# Green Fibre Composite Ltd.

Baniarchala, Mohoha Bhabanipur, Gazipur Sadar, Gazipur  
(24.166900, 90.418758)  
13 November 2022

# Observations

**Few beams have marginally insufficient flexural reinforcement**

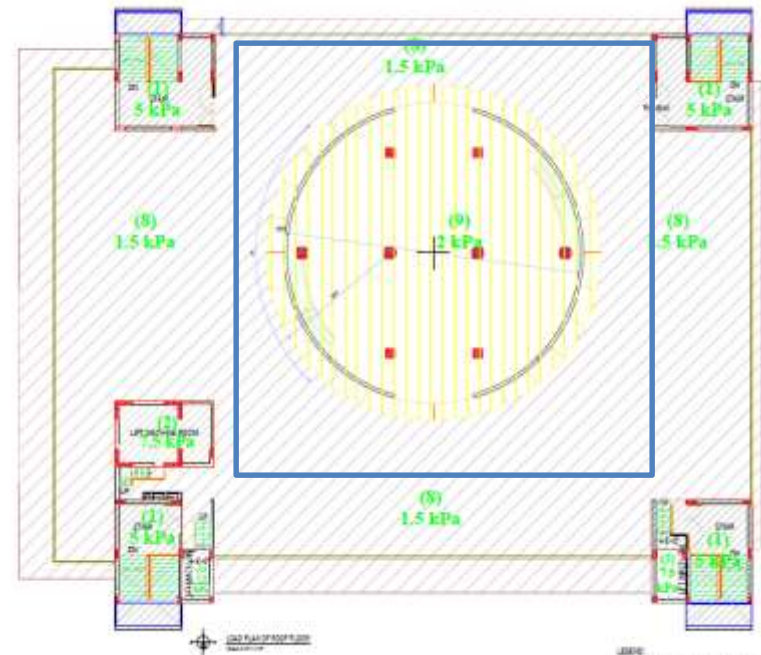
As per the design report few beams have insufficient flexural reinforcement and strengthen works suggested for those beam. However, strength drawings were not found on site and strengthen works were not carried out. Building engineer is required to review the design of the beams.
